product modification

050-0419-00
M13921

Types 5T1, 5T1A,
3T77, 3T77A

TUNNEL DIODE REPLACEMENT

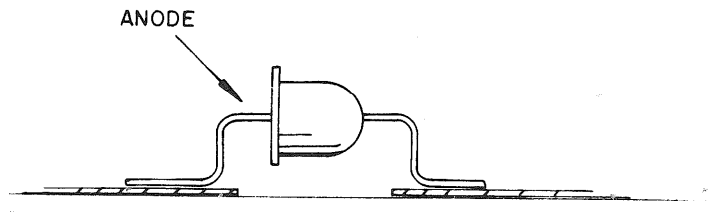
Tunnel Diode 152-0381-00, with axial leads, replaces Tunnel Diode 152-0074-00, a ribbon lead diode, which is no longer available. To install the axial lead diode, it will be necessary to remove the diode clip, in those applications where it is used, and solder the leads of the new diode directly to the circuit board.

- ## () Remove the diode* (noting how it is mounted) and the clip (if one is used) from the instrument, and solder in the new diode as shown in the drawing below.

*Instrument Type -- 5T1/A D255 or D325
3T77/A D74
